Reference: 261-277 King Edward Avenue & 260 Murray Street
Transportation Overview – Addendum #1
Our File No. 112078

The purpose of this letter addendum is to review the revisions to the proposed site plan as a result of the comments received from the City.

REVISED SITE PLAN

2 SITE PLAN
SCALE 1:150

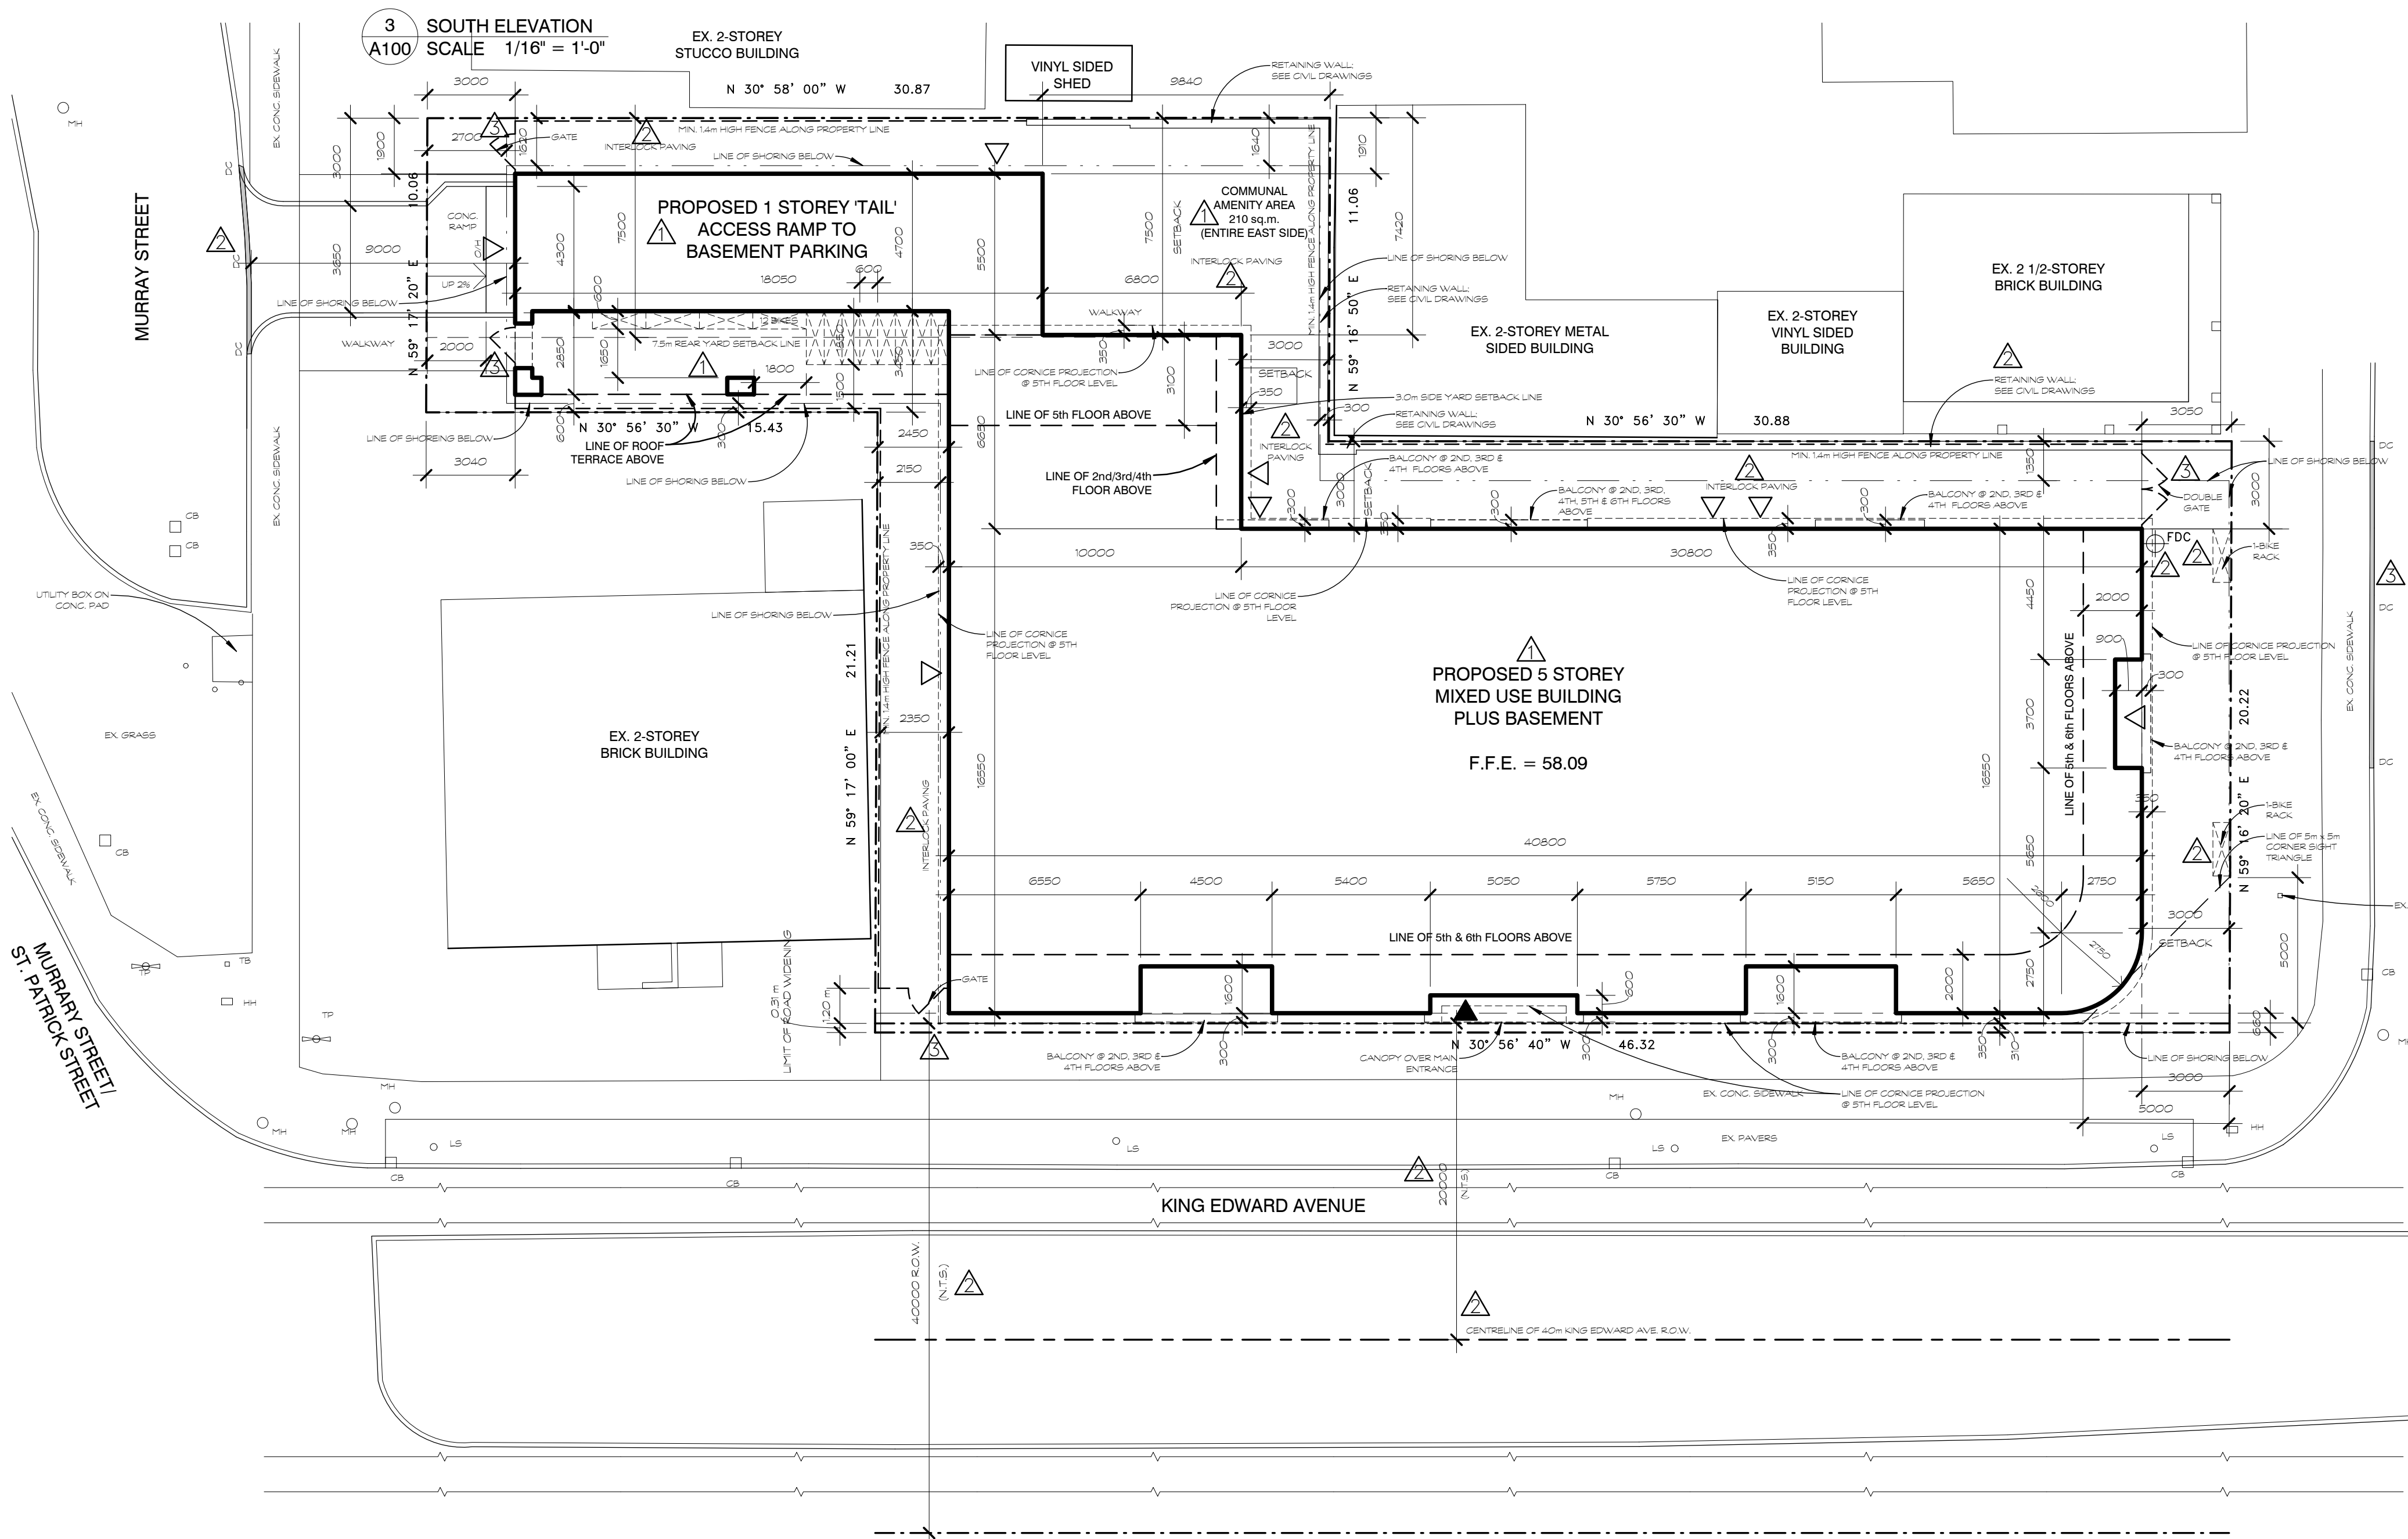
Since the original submission, the site plan has been revised. The revised site plan has reduced the number of apartment units from 31 to 23, and increased the GFA for the retail component from 4,520 s.f. to 5,500 s.f. The revised site plan also removes the underground parking garage on Clarence Street, reduced the width of the Murray Street access to 3.6m, and reduced the number of spaces in the Murray Street parking garage to 19. The number of bicycle parking spaces have also been reduced to 14.

The revised development has removed the parking garage accessed from Clarence Street. The width of the Murray Street access has been reduced to 3.6m at the property line. The City of Ottawa's *Zoning By-law* (ZBL) identifies a maximum width of 3.6m for a double traffic lane that leads to less than 20 parking spaces.

The revised site access is located approximately 3m from the easterly property line and 3.4m from the westerly property line, satisfying the minimum spacing requirements identified in the City of Ottawa's *Private Approach By-law*.

Based on the foregoing table, the ZBL identifies a requirement to provide 14 bicycle parking spaces for the proposed development. As shown on the revised site plan, two bicycle parking spaces are provided along Clarence Street and 12 bicycle parking spaces will be provided in an enclosure adjacent to the Murray Street access.
